**Economic and Social Council**Distr.: General
10 February 2016

World Forum for Harmonization of Vehicle Regulations**Working Party on General Safety Provisions****110th session**

Regulation No. 110 (CNG and LNG vehicles)**Proposal for amendments to Regulation No. 110
(CNG and LNG vehicles)****Submitted by the experts from the Netherlands and International
Association for Natural Gas Vehicles***

Figure 1
Dimensions of the receptacle

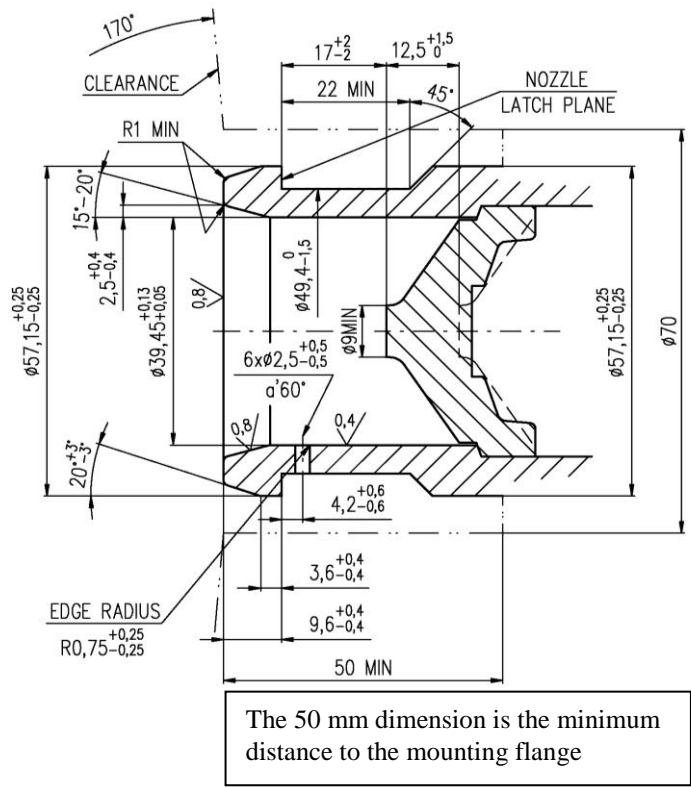
- "4. **LNG filling unit dimensions**
- 4.1. **Figure 1 shows the dimensions of the LNG filling unit.**
